**Response to Request for Information (DA23/15294)  
Digital Advertising Sign – Pacific Highway, Hornsby**

This letter has been prepared by *Keylan Consulting Pty Ltd* (Keylan) on behalf of Sydney Trains (the Applicant) to address the Department of Planning, Housing and Infrastructure (DPHI) Request for Additional Information (RFI) dated 12 March 2024 in relation to Development Application (DA23/15294).

### Response to issues raised by DPHI dated 12 March 2024

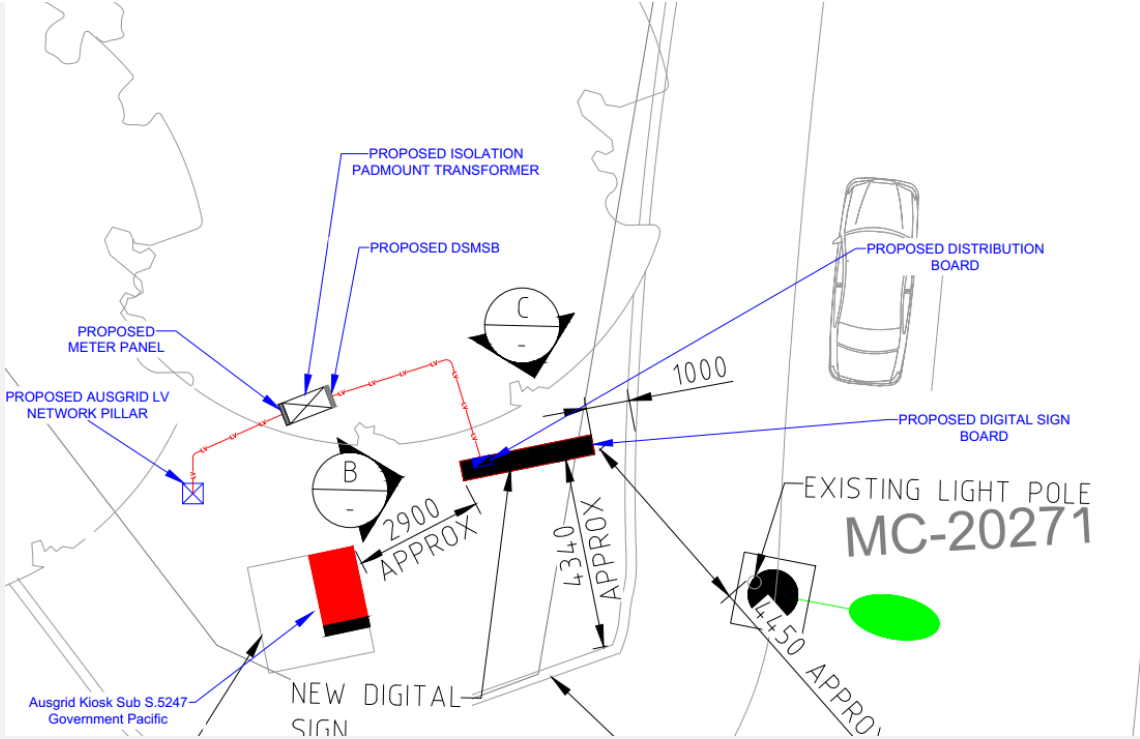
4	<p><b>Risks associated with the digital sign outcompeting directional signages</b></p>	
4.1	<p><i>There is no acknowledgement that from certain points the proposed sign and directional sign would be in the same vertical field of view. As such, the sign could outcompete the directional sign for the driver's attention. Further, the assessment only discusses the visibility and legibility of the directional sign and not the impact that it would have on lane-choice implications and possible multiple manoeuvres as drivers change lanes.</i></p> <p><i>Please address the impacts that the proposed signage could have on drivers' decision-making elements, such as changing-lanes, which would be made based on the directional signage.</i></p>	<p>As outlined within the TTPP response (Attachment B), the digital advertisement sign is not considered to compete with directional signages given:</p> <p><i>The sign would not be positioned directly below the directional signage and therefore not within the same vertical field of view as it is offset on the left side of the road, as opposed to the directional sign which is situated above the roadway. This is evident in the signage exposure images in Section 2.3 of the SSA report attached in Attachment Three.</i></p> <p><i>The directional sign would be visible from 115m away and is situated approximately 20m south of the proposed digital sign. The driving approach from 115m away to the directional sign is presented below in Figure 5. As evident, the proposed digital sign would be obscured by poles and vegetation at this point, and the directional signage would be clearly distinct situated above the roadway. The digital sign would be visible approximately 20m after the directional sign comes into view.</i></p> <p><i>Drivers requiring directional guidance would primarily be focussed on the directional signage and would have visibility of this sign before the digital sign comes into view. They would be able to make their lane change with adequate time before the traffic signals, so this is not considered a safety risk.</i></p> <p><i>Furthermore, as discussed above there is no evidence that there is a crash risk at this location even despite the existing static sign (which is larger than the proposed digital sign).</i></p>

Ref.	Issues raised	Response
		 <p data-bbox="804 959 1321 986">Figure 6: Driving approach to directional signage</p>
5	<b>Inconsistency with the Transport Corridor Outdoor Advertising and Signage Guidelines</b>	
5.1	<p><i>The placement of the sign is inconsistent with Section 3.2.3 of the Transport Corridor Outdoor Advertising and Signage Guidelines (Department of Planning and Environment, 2017) (the 2017 Guidelines). Section 3.2.3 of the 2017 Guidelines states that an advertising sign should not be located where it is visible from the terminating leg of a T-intersection. The sign would be visible from Government Road</i></p>	<p>This is addressed in the Distraction Risk section; it is not seen as a safety risk due to the location of the sign.</p>

Figure 8: Buried Services Plan (Source: JCDecaux)

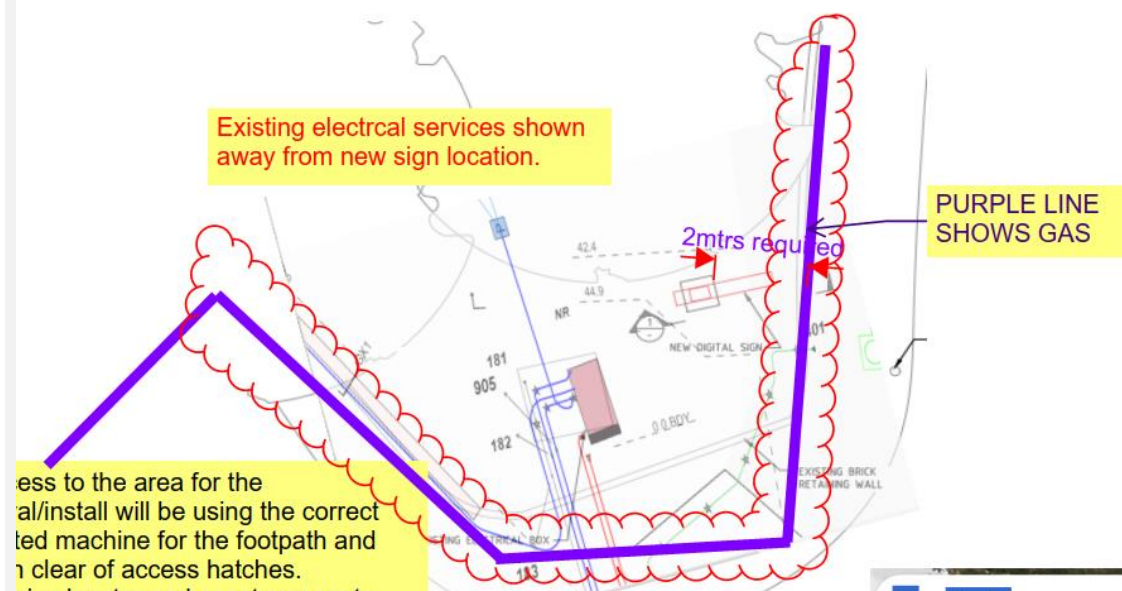
- Details on utility services required to operate the sign have not been included. Please advise whether the services form part of the development or if they will be provided under another approval pathway. If these are to form part of the development application, details must be provided on the services along with an assessment of the construction impacts associated with providing the services.
- No details have been provided on the existing buried services, noting that there is a high pressure gas main in the vicinity of the proposed sign. Please provide details on all existing buried services and the measures that would be implemented to protect these during construction of the proposed sign.

To ensure services remain protected during the construction phase the following processes will be adopted:

- The use of a utility mapping service provider to mark the exact location of the services (physical). They can also be present during excavation.
- If required to be present during excavation works the use of second field officers can be available to monitor the excavation if the gas, electrical and other services are within the prescribed distance that requires asset owners observation to be present during works that could impact assets.
- Load spreading plates and protective matting to be used as minimum.
- The use of craneage to lift machinery into and out of the site to avoid weight restrictions of the footpath and services within.
- Use equipment that is approved to work on footpath and is within prescribed weight restrictions

Ref.	Issues raised	Response
		<ul style="list-style-type: none"> <li>• Increase machine sizes to allow to work from roadside under ROL's (EWP's, cranes etc)</li> <li>• Exclusion zones implemented and maintained during construction phase by spotter. (NO GO ZONE)</li> </ul>

**Figure 4: Driver Exiting Government Road onto Pacific Highway**

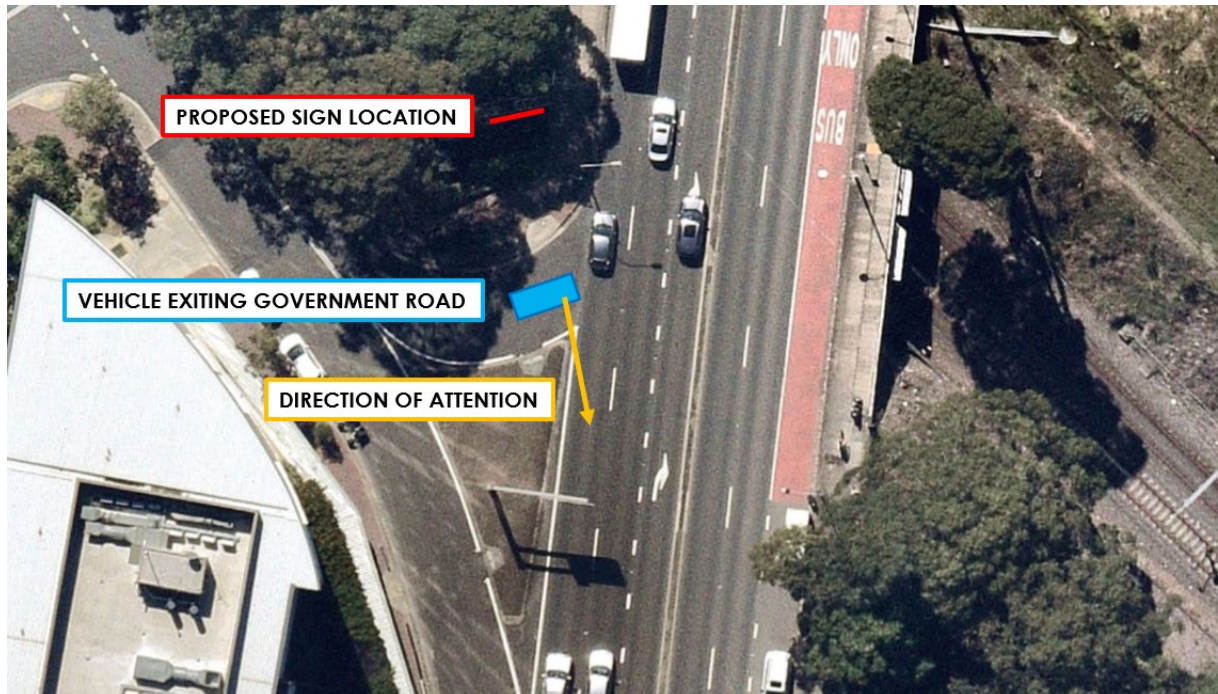
Ref.	Issues raised	Response
	<p><i>acknowledge that the sign would be visible to drivers exiting from Government Road and that they would need to look left before pulling out to make sure that the traffic lane is clear and that there are no stopped vehicles preventing them from turning onto the highway;</i></p> <ul style="list-style-type: none"> <li><i>motorists and cyclists turning left into Government Road from the Pacific Highway; and</i></li> <li><i>pedestrians heading north along the highway and crossing over Government Road.</i></li> </ul> <p><i>The assessment should be based on the worst-case scenario that the sign will be highly distracting.</i></p>	<p><i>lane. The proposed digital sign would be located at a 90-degree angle from a stopped vehicle and would only be observable by looking left through the side window. This would be in the opposite direction drivers and cyclists are focussed on as shown in Figure 4. (Figure 4 below).</i></p> <p><i>Therefore, TTPP deems that it would be highly unusual for drivers exiting Government Road to be looking out the left side window to observe the sign and is therefore not considered a safety risk. This would be the case for cyclists as well, which were not observed along Pacific Highway during our site inspection</i></p> <p>Motorists and cyclists turning left into Government Road from the Pacific Highway.</p> <p><i>A driver and cyclist will be able to turn left into Government Road from Pacific Highway with clear vision towards pedestrians crossing because of the angle of approach as shown in Figure 1 (Figure 5 below).</i></p> <p>Pedestrians heading north along the highway and crossing over Government Road.</p> <p><i>There is clear visibility towards pedestrians waiting to cross, or travelling north on Government Road due to the low angle of the left turn lane on approach. There have also been no incidents at this crossing location in the last 5 years so there is no discernible inherent crash risk at this location, even with the existing large format static sign.</i></p> <p><i>Furthermore, pedestrians travelling north along Pacific Highway have sufficient time to process signs and messages and therefore, are unlikely to be distracted by the proposed digital sign when crossing. Similar to drivers and cyclists, pedestrians would be looking towards oncoming traffic from Pacific Highway away from the proposed digital sign to find suitable gaps in traffic before crossing Government Road.</i></p>

Whilst on site, it was observed by TTPP that drivers were focussed on oncoming traffic when turning into Pacific Highway from Government Road. When pulling out drivers were looking out the front window for traffic within the traffic lane. The proposed digital sign would be located at a 90-degree angle from a stopped vehicle and would only be observable by looking left through the side window. This would be in the opposite direction drivers and cyclists are focussed on as shown in Figure 4.

Therefore, TTPP deems that it would be highly unusual for drivers exiting Government Road to be looking out the left side window to observe the sign and is therefore not considered a safety risk. This would be the case for cyclists as well, which were not observed along Pacific Highway during our site inspection.
